1 (3)  
Our file code  
CEN/TC 158/WG 9 N 24

CEN/TC 158 Head protection  
WG 9 Helmets for alpine skiers

## Shock absorption test according to EN 1077: problem of helmet positioning

Positioning 1: Marked impact point impacted correctly (CoG not aligned)      Positioning 2: CoG aligned, but impact point displaced

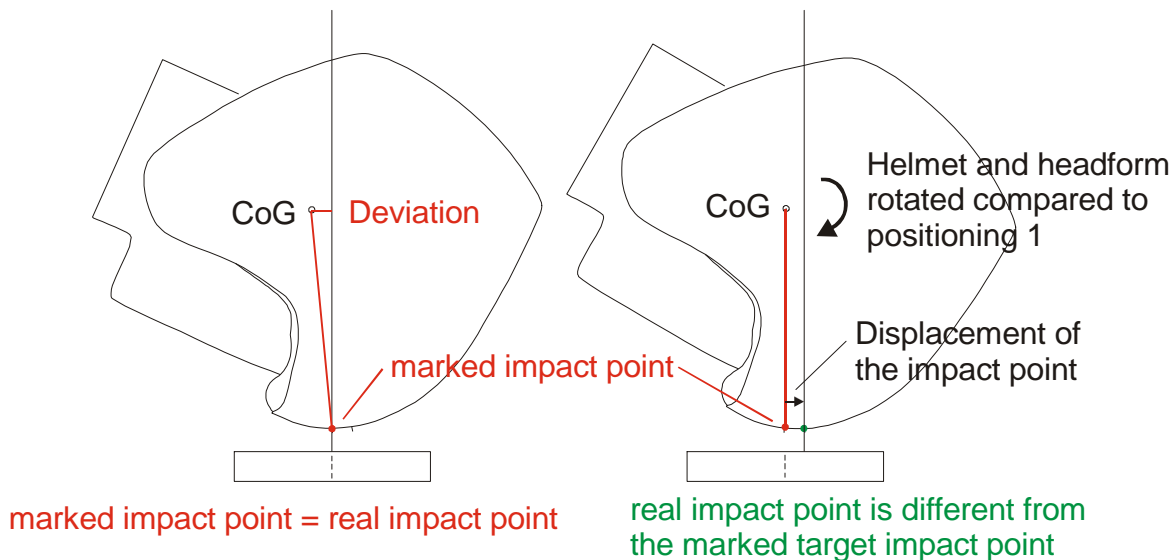
The following two positioning methods both seem consistent with standard EN 1077, see also figure:

1. Alignment of the marked impact point (=target impact point) with the anvil centre, whereby the anvil surface is approximately tangential to the helmet shell at the marked impact point. The impact is directed only approximately towards the centre of gravity of the headform.
2. Alignment of the marked impact point with the centre of gravity of the headform and the anvil centre. Compared to positioning 1, the helmeted headform has to be rotated which leads to the fact that actually a point different from the marked impact point is impacted in the shock absorption test (this is evident from the analysis of the damage to the helmet liner, see photographs 1 and 2).

The correct alignment of the target impact point and the centre of the anvil should be preferred (procedure 1) because of the higher test precision. If the other method is used, the safety of certain helmet designs is not guaranteed over the whole frontal test area, because impact points in the lower part of the frontal test area will never be tested. The problem should be brought to the attention of the responsible CEN Working Group, so that the text of EN 1077 could be revised and clarified in this respect.

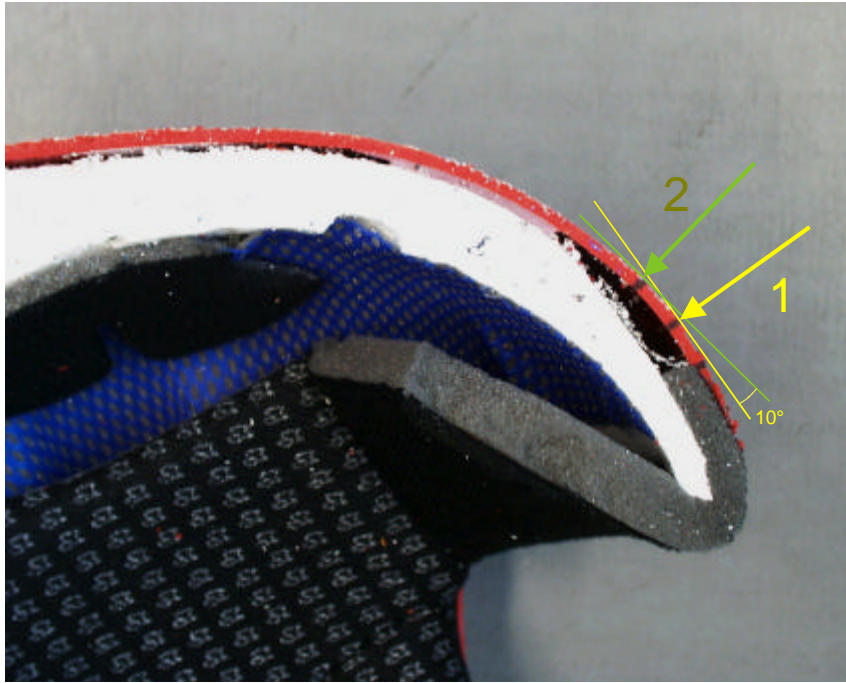
According to the experience of EMPA, the difference between the positioning methods can be very important in frontal impacts, because the helmet liner gets thinner towards the front edge for various ski helmet models. In this case, a shock absorption test result can be either negative if the positioning 1 is used (the marked impact point is impacted correctly) or positive with positioning 2 (instead the marked target impact point a point displaced to the crown area is impacted).

**Photo 1:** Liner damage observed after a shock absorption test using positioning procedure 1 (max. deceleration 264 g). The yellow arrow indicates the direction of the impact and the impact point 1 which coincides with the defined target impact point (see the corresponding black marking on the red shell). The yellow line indicates the anvil surface at the moment of the contact. The surface of the compressed liner runs parallel to this line. The lowest black marking on the red shell indicates the border of the frontal impact zone.

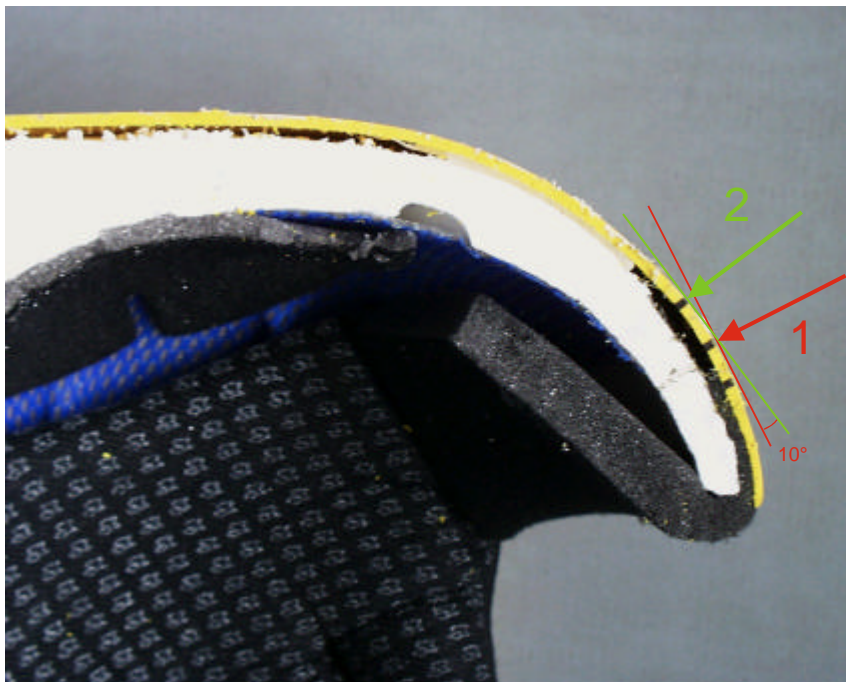
**Photo 2:** Liner damage observed after a shock absorption test using positioning procedure 2 (max. deceleration 190 g). The green arrow indicates the direction of the impact and the impact point 2 which does not coincide with the defined target impact point 1 (see the corresponding black markings on the red shell). The green line indicates the anvil surface at the moment of the contact. The surface of the compressed liner roughly runs parallel to this line and maximum compression occurred below the impact point 2, i.e. at a point different from the marked target impact point. Because the helmet was tested at a point, where the liner is thicker, the observed compression of the liner material is smaller than that in Photo 1.
